STATE OF VERMONT AGENCY OF TRANSPORTATION

PROPOSED IMPROVEMENT BRIDGE PROJECT TOWN OF BRIDPORT COUNTY OF ADDISON VT ROUTE 125 (MAJOR COLLECTOR) BRIDGE NUMBERS 2 AND 5

PRE-CONTRACT PLANS
5/16/2014

DIRECTOR OF PROGRAM DEVELOPMENT	
APPROVED _____	DATE _____
PROJECT MANAGER : MARK SARGENT, P. E.	
PROJECT NAME : BRIDPORT	
PROJECT NUMBER : STP CULV (29)	
SHEET 1 OF 53 SHEETS

PROJECT NAME:	BRIDPORT	PLOT DATE:	5/16/2014
PROJECT NUMBER:	STP CULV(29)	DRAWN BY:	L. BUXTON
FILE NAME:	zllc264typsec.dgn	DESIGNED BY:	J. HUNGERFORD
PROJECT LEADER:	M. CHENETTE	CHECKED BY:	M. CHENETTE
TYPICAL SECTIONS - BR2			SHEET 8 OF 53

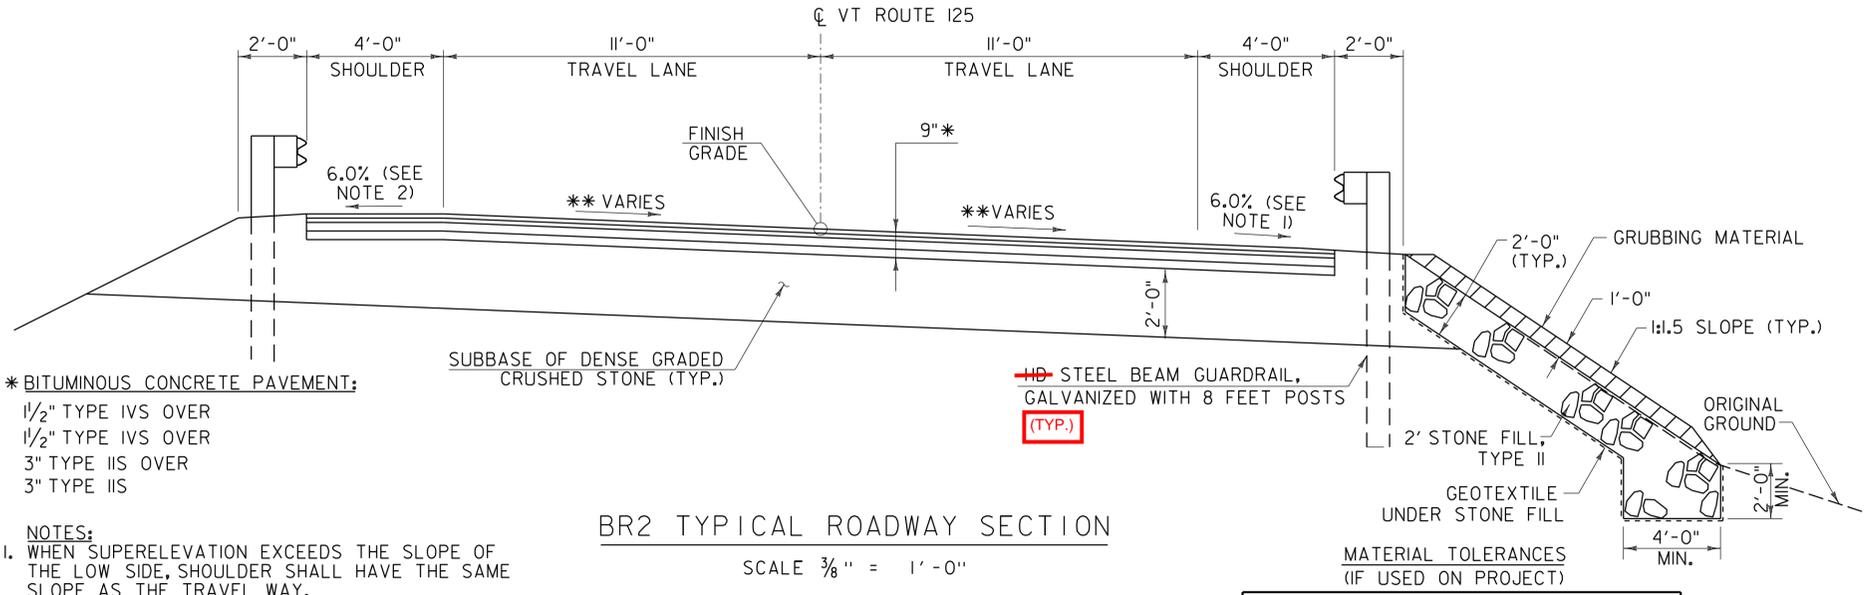
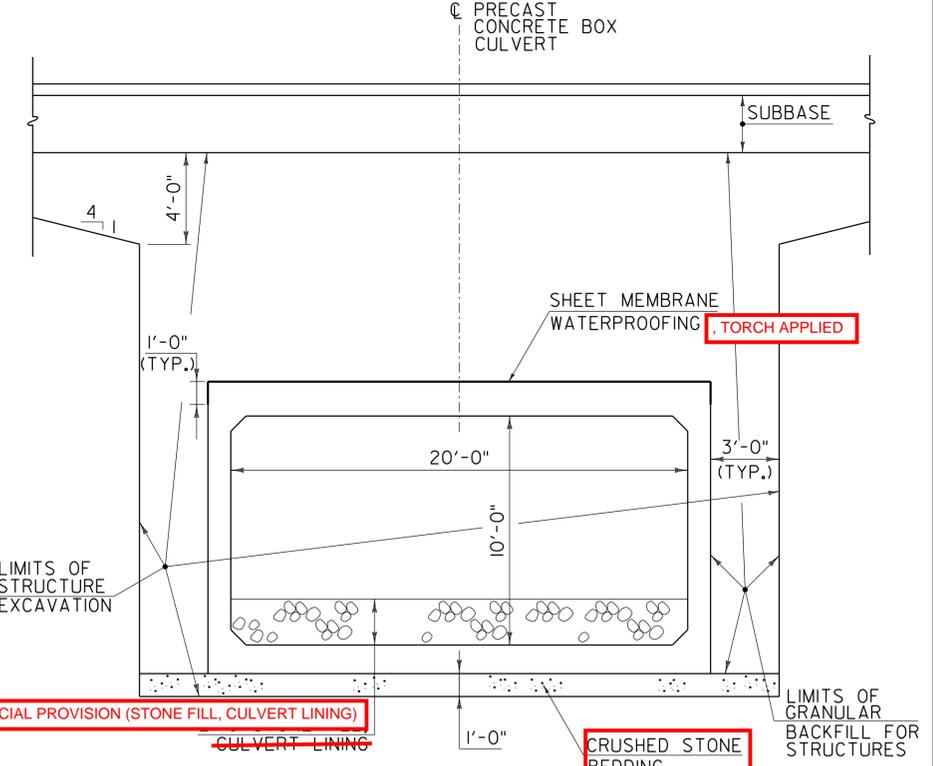
Change to GRANULAR BACKFILL FOR STRUCTURES in fabric as on Sheet 33?

BRIDPORT DETOUR PLAN - BR2  
NOT TO SCALE

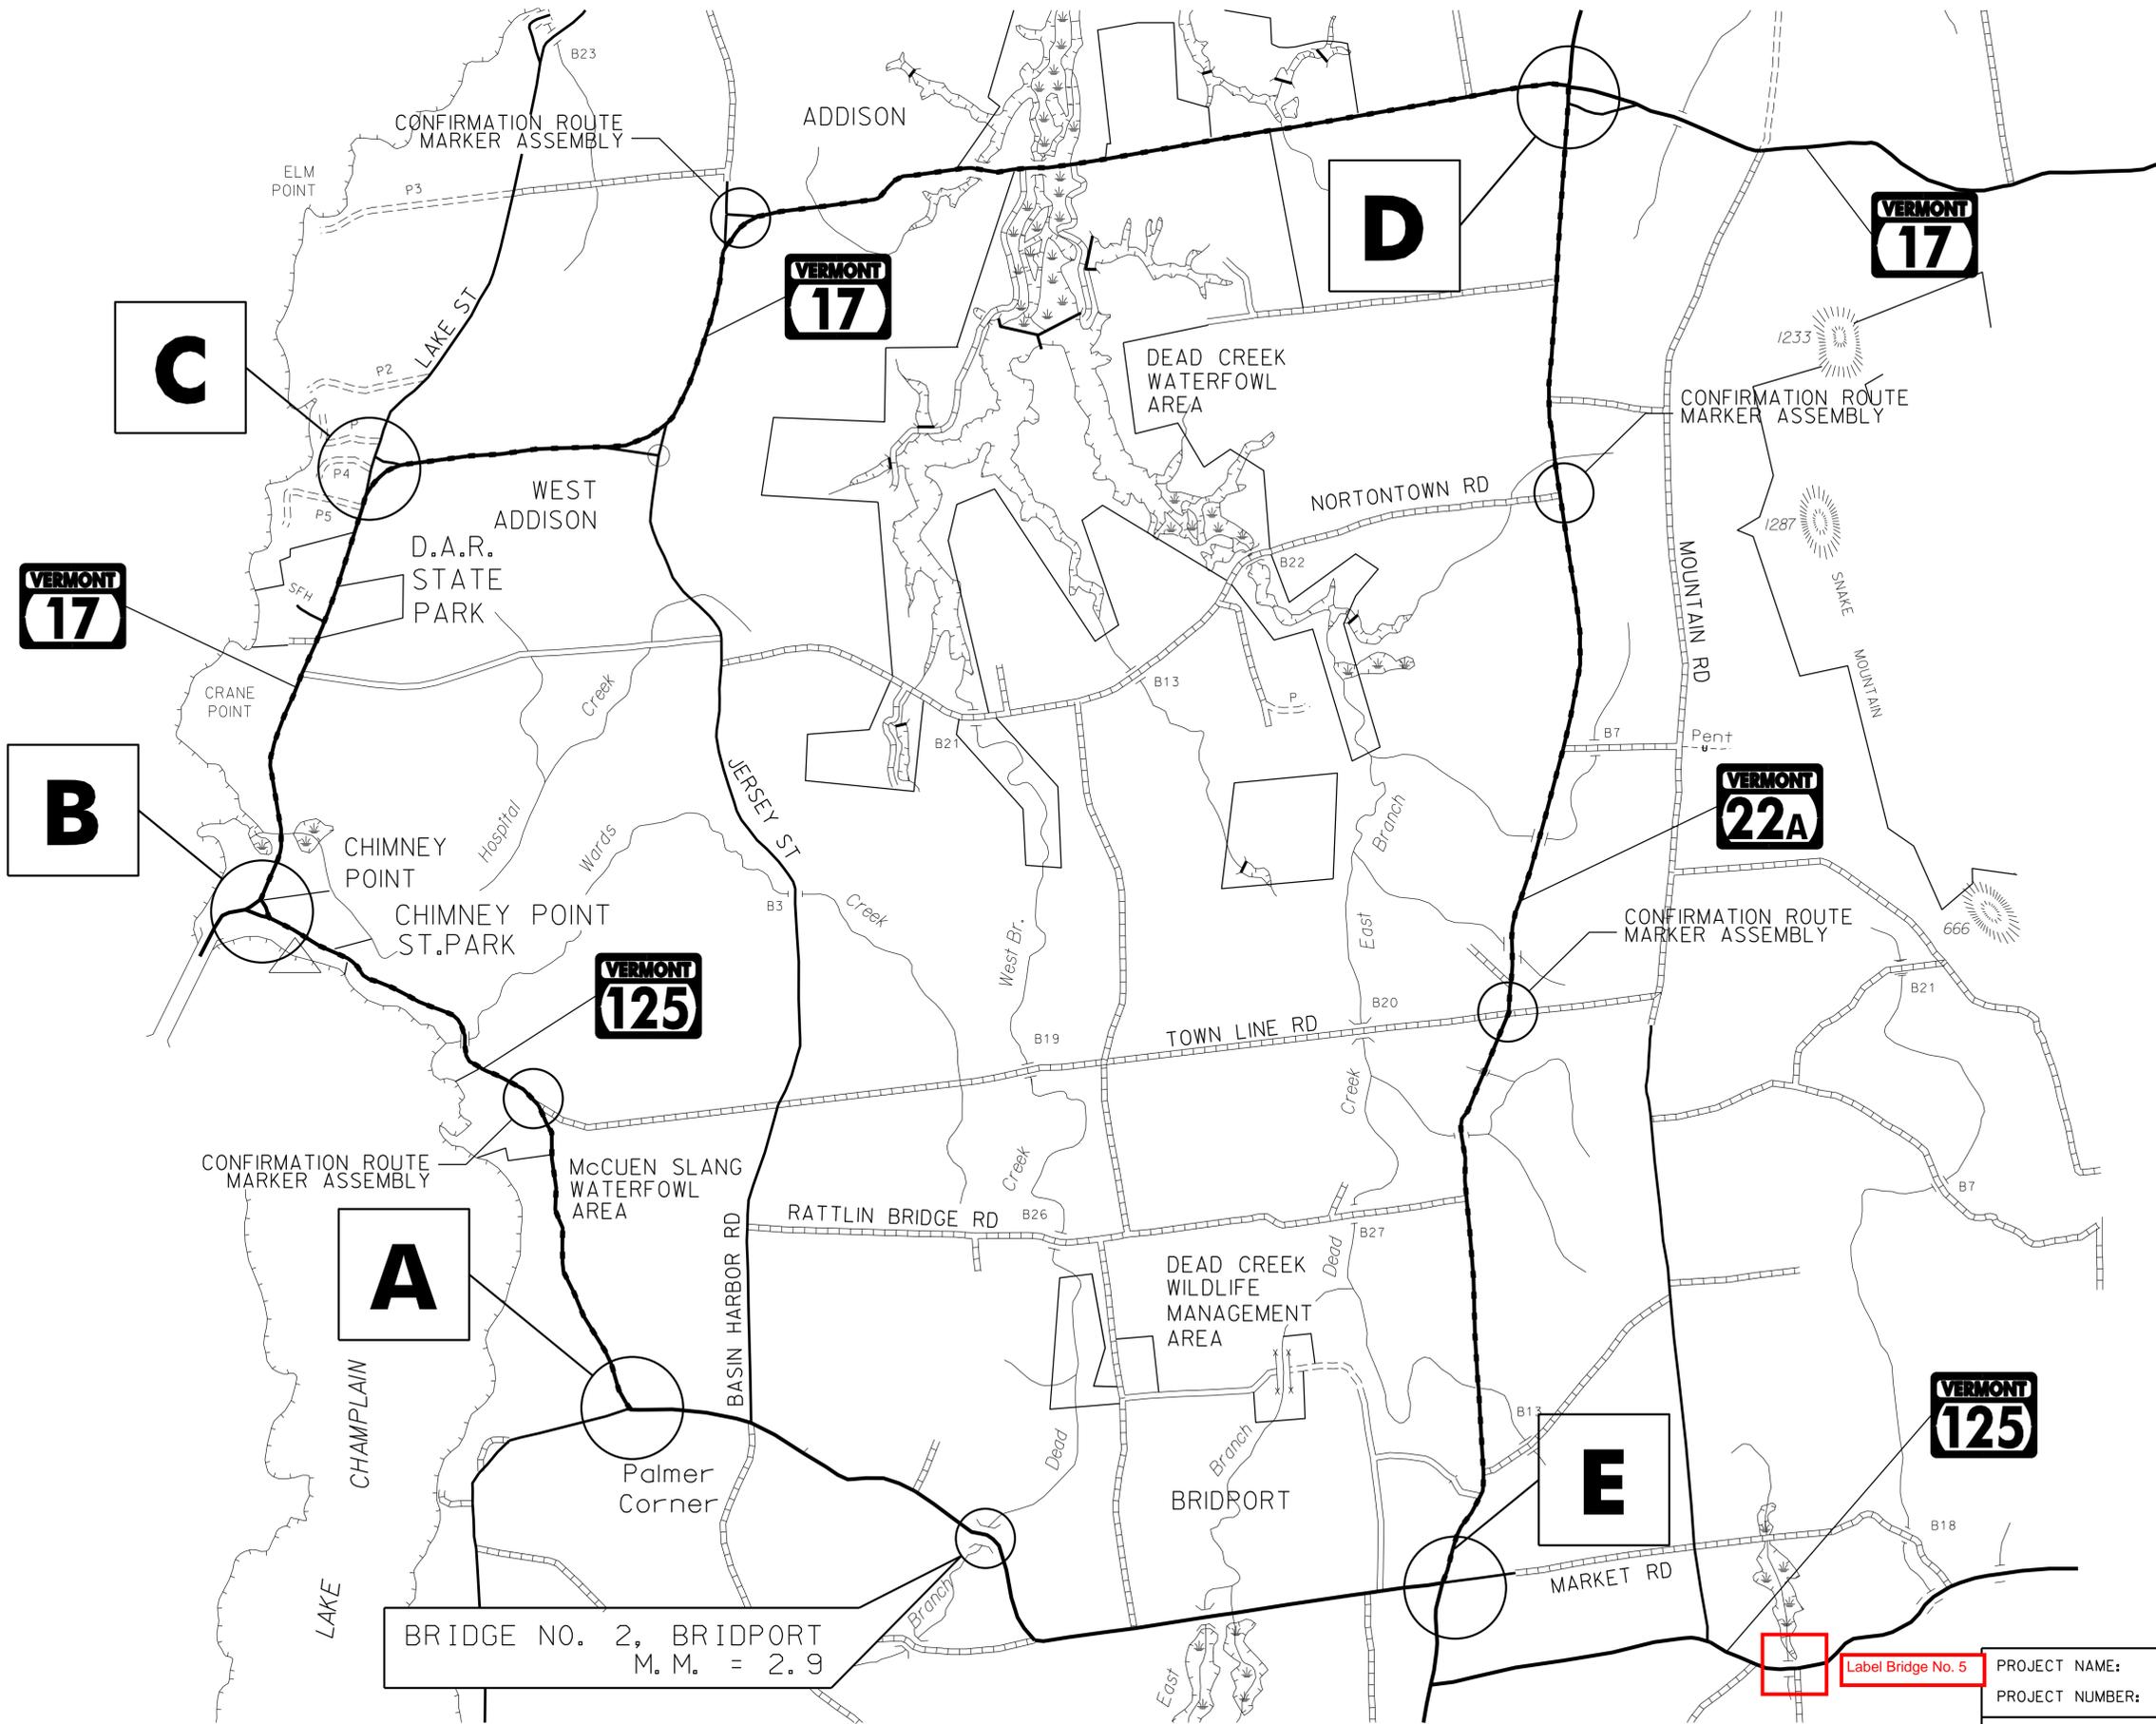
Label Bridge No. 5

PROJECT NAME:	BRIDPORT	PLOT DATE:	5/16/2014
PROJECT NUMBER:	STP CULV(29)	DRAWN BY:	I. MAYNARD
FILE NAME:	zllc264tcdet_br2.l.dgn	CHECKED BY:	J. HUNGERFORD
PROJECT LEADER:	M. CHENETTE	SHEET	15 OF 53
DESIGNED BY:	I. MAYNARD		
TRAFFIC CONTROL DETAILS I - BR2

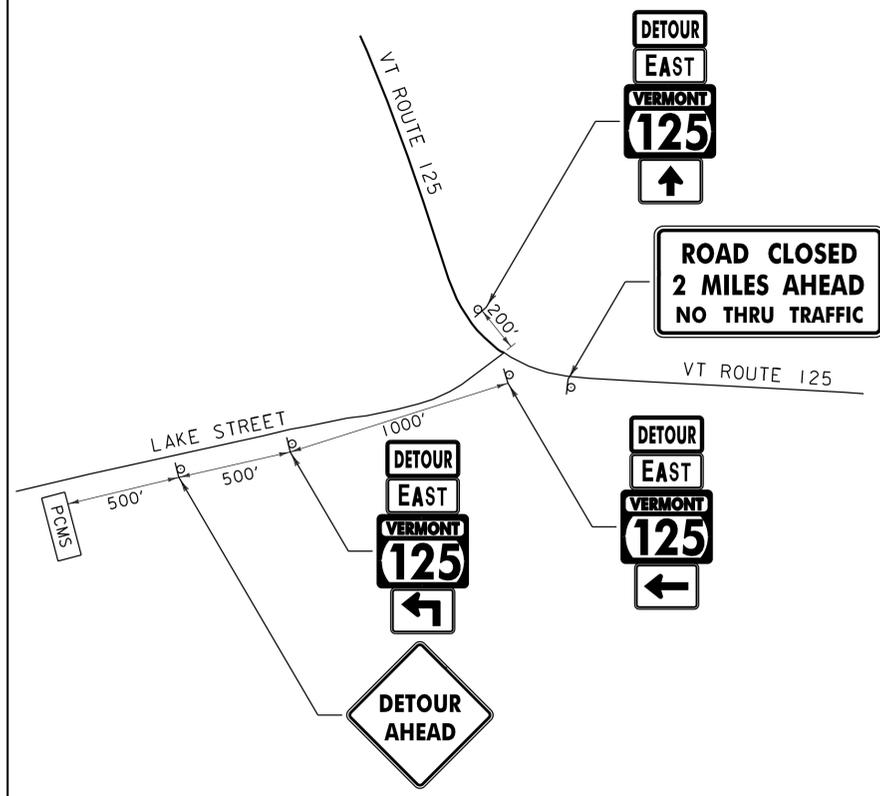
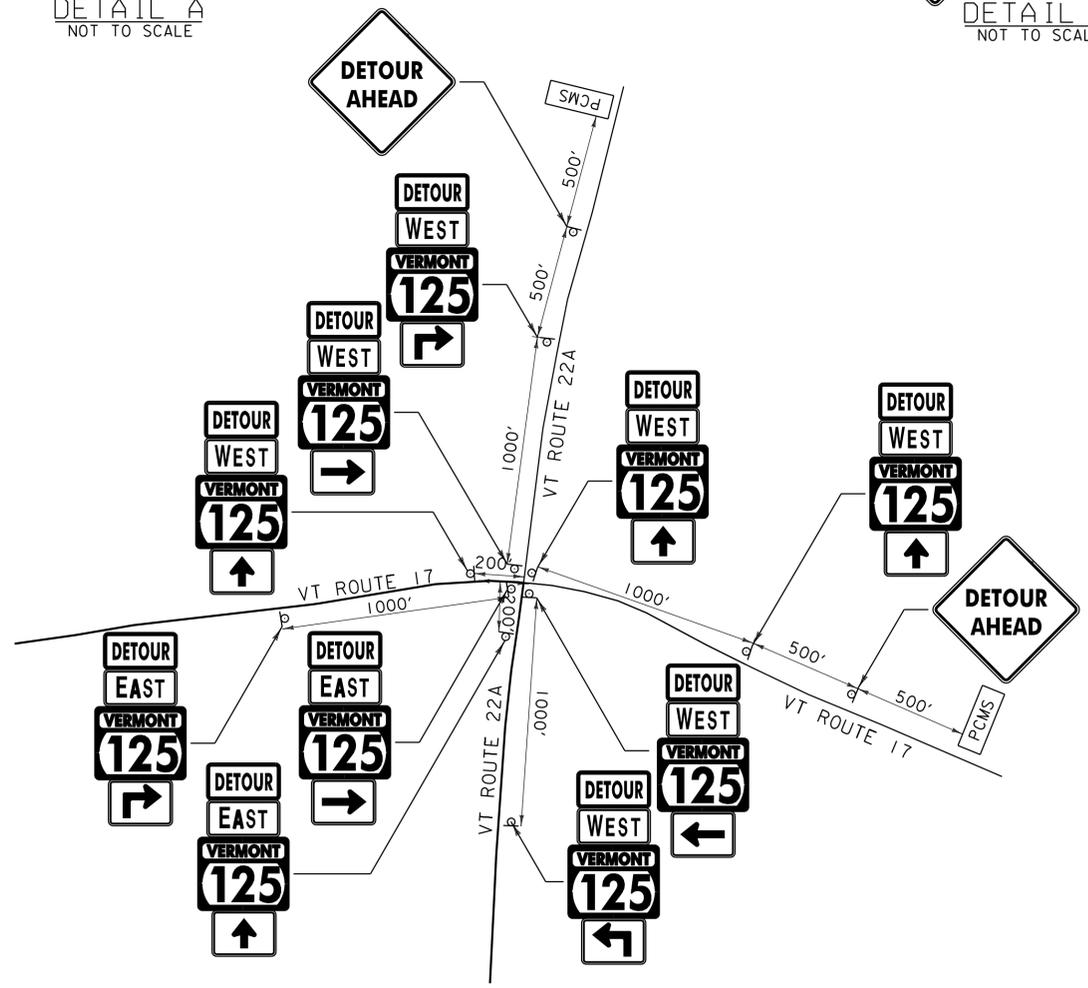
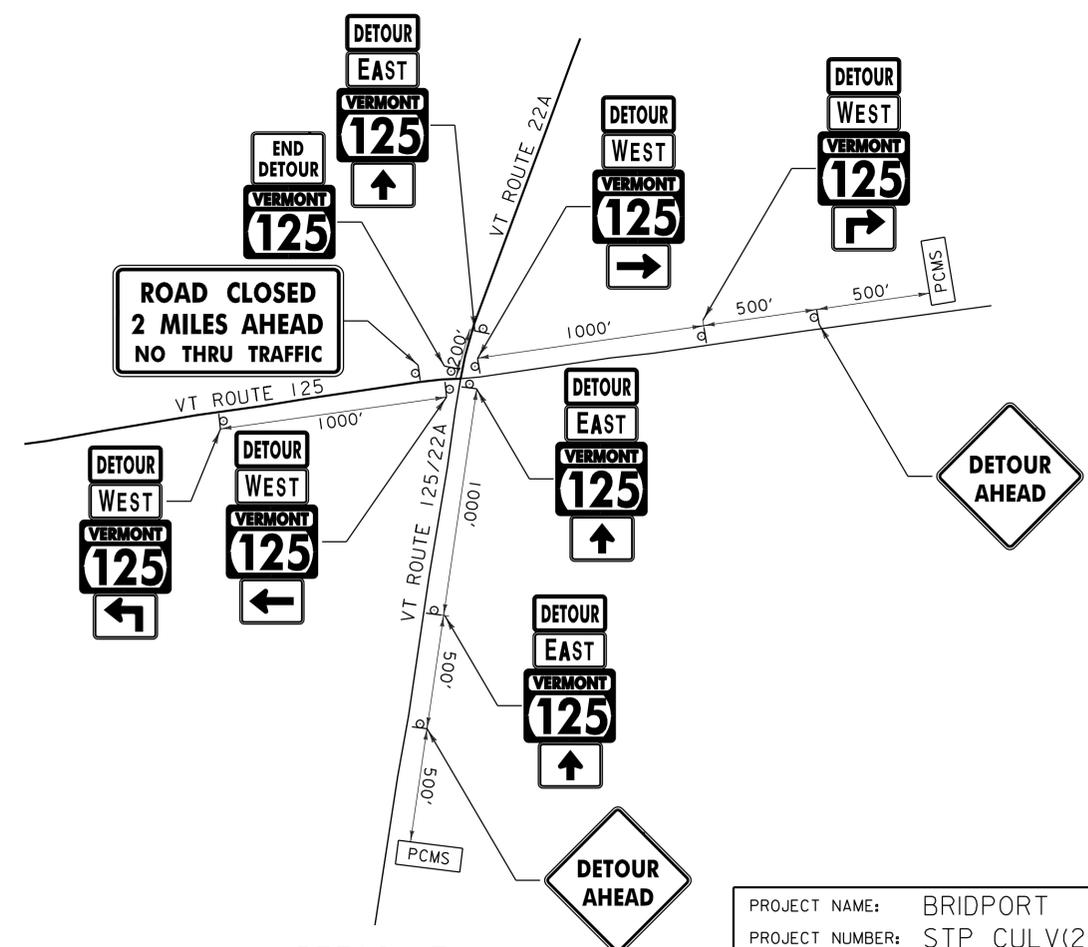
PCMS = PORTABLE CHANGEABLE MESSAGE SIGN Not used here; more appropriate for Sheet 15.
